# Access Compliance Report

## Public Rights-of-Way

Intersection ID: 24469	Main Street: MIROW_PL	Cross Street: SAINTFIELD_PL	Location: SW
ADA ID: 420316DEE038	Ramp Type: PerpDiag	Initial Pass/Fail: Fail	Overall Compliance: No
Severity Score: 12.5			
Codes/Mitigation Info/Possible Solution		Field Measurements/Component Compliance

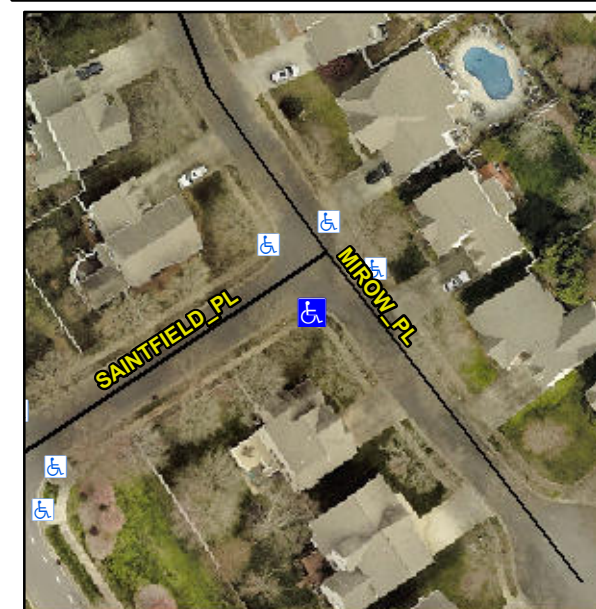
**Remove & Replace Curb Ramp With Two New Directional Ramps or Equivalent.**

**Not Found, R304.5.3**
